# Access Compliance Report

## Public Rights-of-Way

### (Curb Ramps)

Intersection ID: 18436	Main Street: E_INDEPENDENCE_BV	Cross Street: SHARON_FOREST_DR	Location: NW
ADA ID: 9193D4B5D4CD	Ramp Type: PerpDiag	Initial Pass/Fail: Fail	Overall Compliance: No
Severity Score: 10			
Codes/Mitigation Info/Possible Solution		Field Measurements/Component Compliance

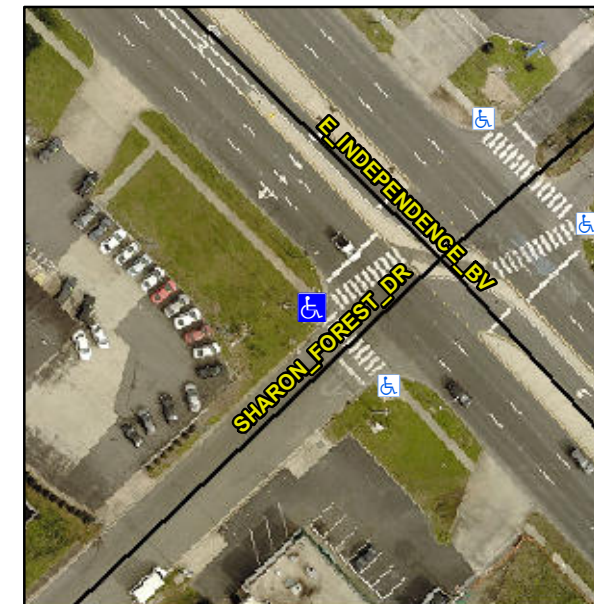
**Not Found, R304.5.1, R304.5.3**

Compliance	Description	Data	Compliance	Description	Data
N/A	Ramp Length (in)	115.5	Yes	Ramp Slope (%)	6.6
No	Ramp Width (in)	39.0	No	Ramp XSlope (%)	5.0
N/A	Flare Type LT	N/A	N/A	Flare Type RT	N/A
N/A	Flare Slope LT (%)	N/A	N/A	Flare Slope RT (%)	N/A
N/A	Flare Traversable LT?	N/A	N/A	Flare Traversable RT?	N/A
N/A	Landing Length (in)	N/A	N/A	DWS Provided?	N/A
N/A	Landing Width (in)	N/A	N/A	DWS Contrast?	N/A
N/A	Landing Slope (%)	N/A	N/A	DWS Length (in)	N/A
N/A	Landing X Slope (%)	N/A	N/A	DWS Full Width?	N/A
N/A	Landing Curb? (Y/N)	N/A	N/A	DWS Offset (in)	N/A
N/A	Shared Landing?	N/A			
N/A	Gutter Ponding?	N/A	N/A	Gutter Slope (%)	N/A
N/A	Gutter Lip Ht (in)	N/A	N/A	Gutter X Slope (%)	N/A
N/A	Painted X Walk1?	Yes	N/A	Painted X Walk2?	Yes
	X Walk 1 Direction	To SE		X Walk 2 Direction	To NE
N/A	X Walk 1 Width (in)	117.0	N/A	X Walk 2 Width (in)	118.0
	X Walk 1 Slope (%)	0.8		X Walk 2 Slope (%)	1.9
	X Walk 1 X Slope (%)	5.3		X Walk 2 X Slope (%)	1.8

**Remove & Replace Curb Ramp With Two New Directional Ramps or Equivalent.**
